DeKalb County Historic Preservation Commission

Staff Report

C. 1741 South Ponce de Leon Avenue, FIELD Landscape Architecture. Install swimming pool, construct deck, construct outdoor kitchen, and install landscaping in backyard. **1247343**

PROJECT:
BERLIN RESIDENCE

DRAWING TITLE:
COA PERMIT SITE PLAN

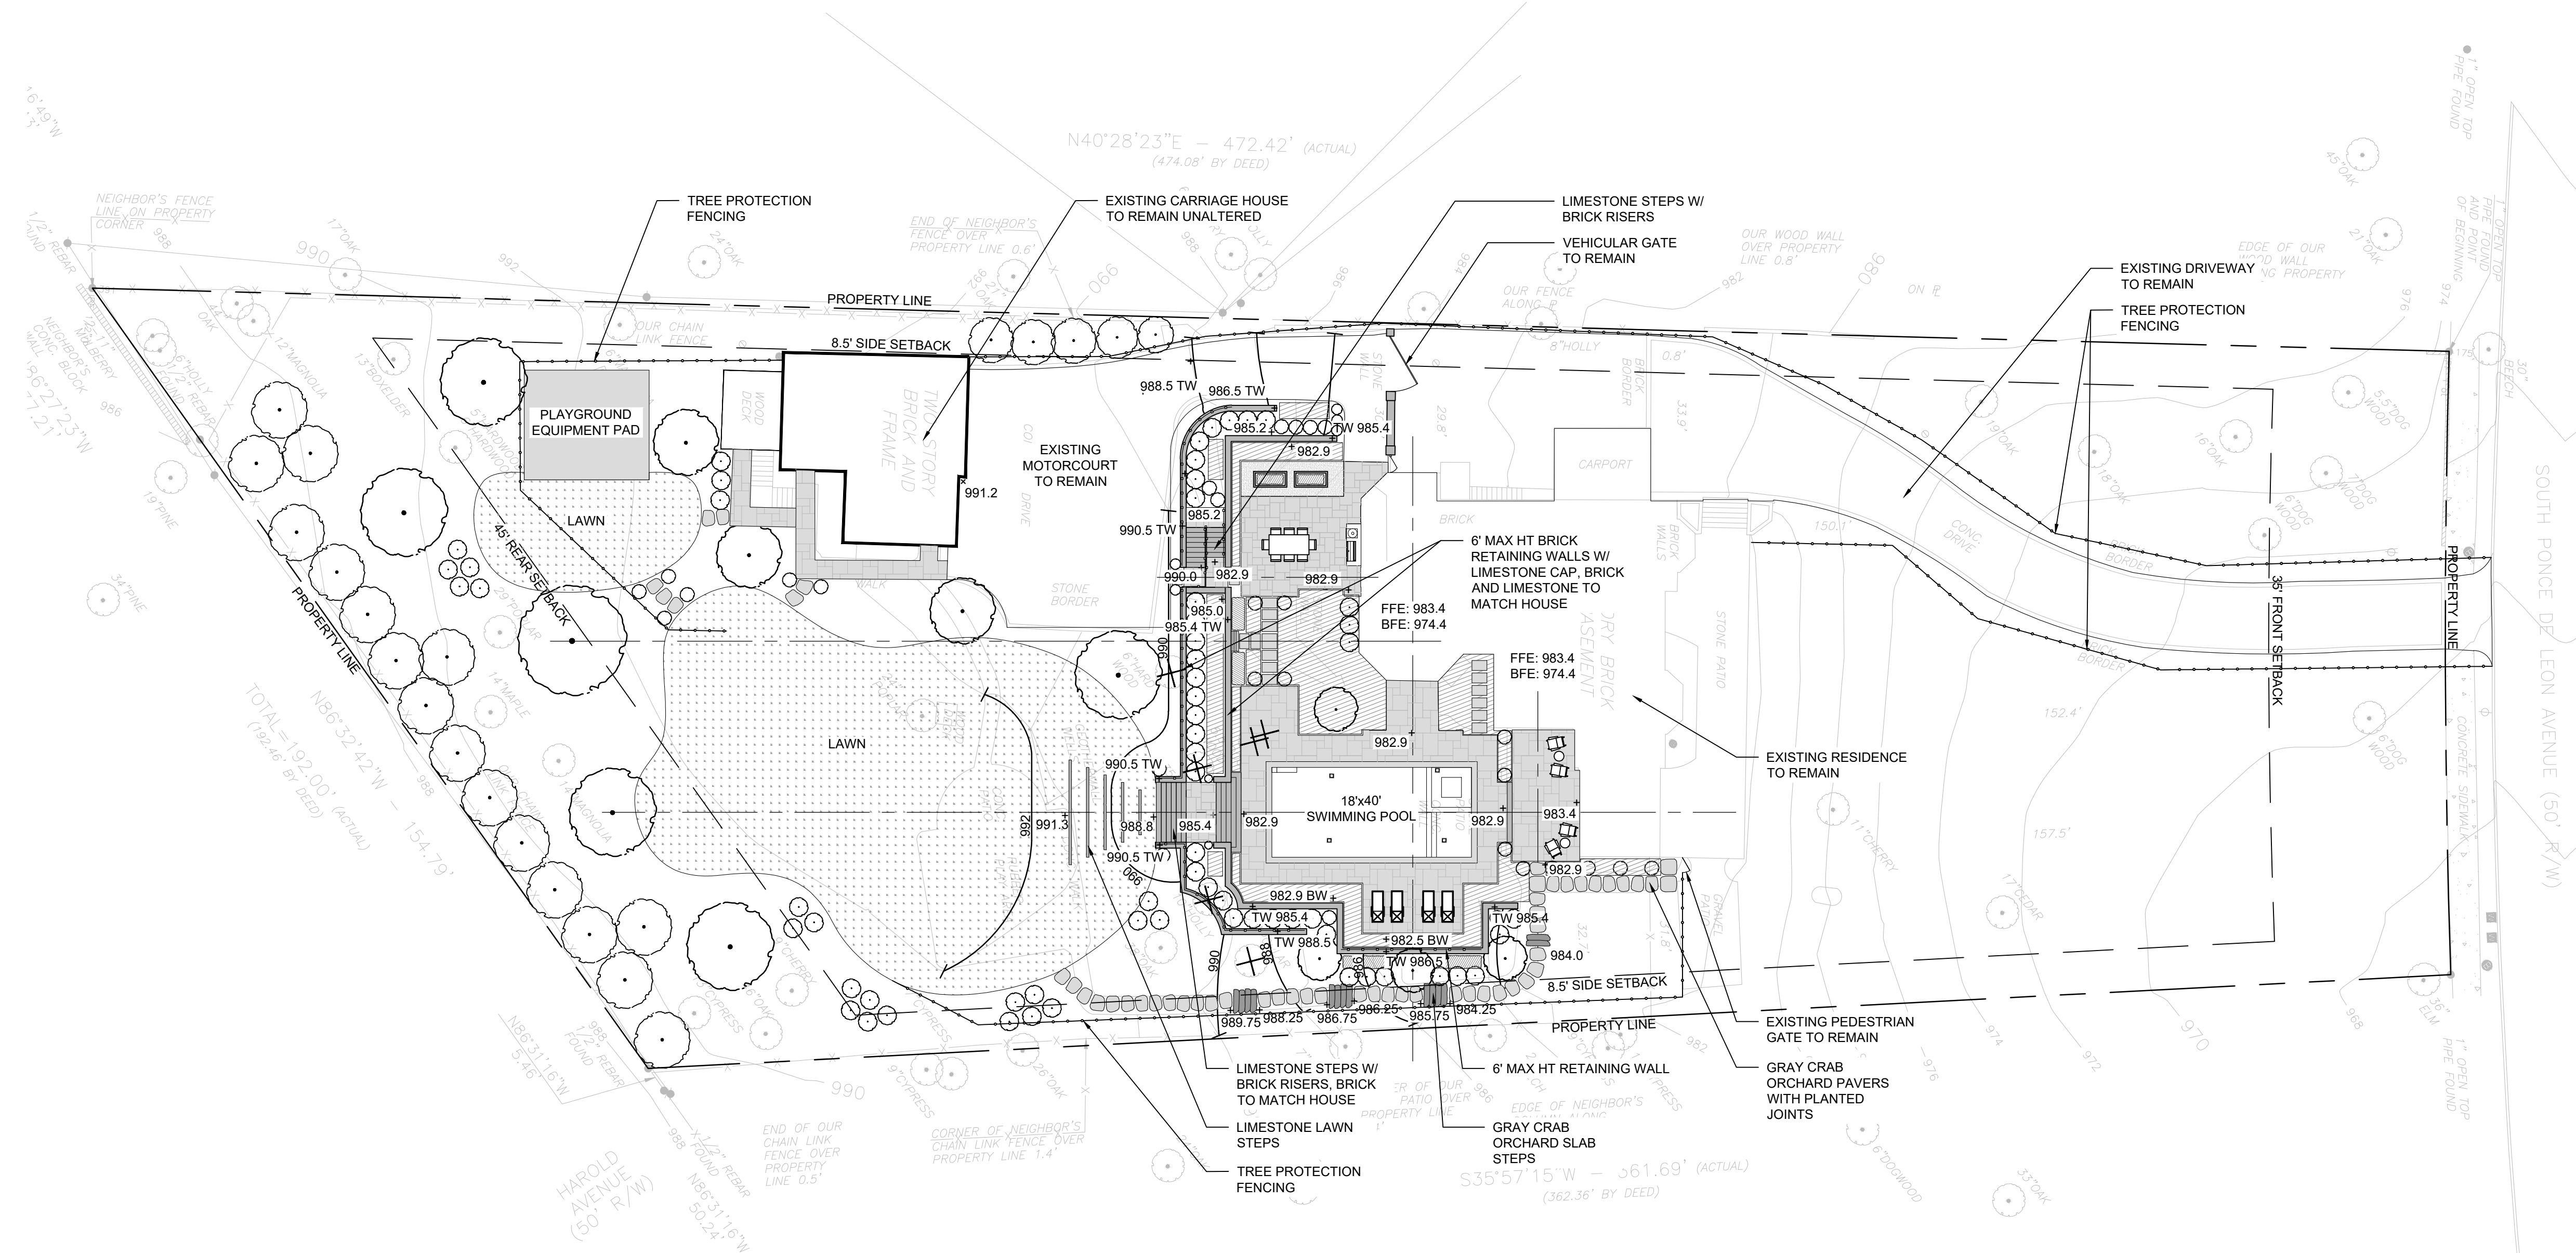
1. Install swimming pool. The existing circular courtyard and fountain located in the backyard will be removed and a swimming pool will be installed. The swimming pool will measure 18' x 40' in size, will be located behind the main structure, and will not be visible from the right of way.

2. Construct a patio in the backyard. A limestone paver patio will be constructed in the backyard of the property, on the rear of the house. The patio area will include a built-in outdoor kitchen element, connecting to the rear of the house.

3. Landscape backyard. The landscaping will include:
 - a. Installing retaining walls. A 6' brick wall with a limestone cap will be installed around the perimeter of the proposed patio and swimming pool area. A secondary 6' brick and limestone retaining wall will be installed running along the brick wall, surrounding the patio and swimming pool area.

- b. Install pathway. A paver pathway with planted joints will be installed beginning at the front-left corner of the main structure and continuing to the back yard along the edge of the patio area and the side-property line.

- c. Install stairway. A set of limestone lawn steps will be installed coming from the patio and swimming pool area and leading onto the rear backyard.

- d. Install new plantings. The plantings will include a number of shrubs and ground coverings, all located within the perimeter of the backyard and will not be visible from the right of way.

Approve. The proposed changes do not appear to have a substantial adverse effect on the property or the district. This application appears to meet the guidelines and the staff recommends approval.

It should be noted that the height of the proposed walls located in the rear yard may require a variance in accordance with DeKalb Code Section 5.4.7., however, this does not have any bearing on the Historic
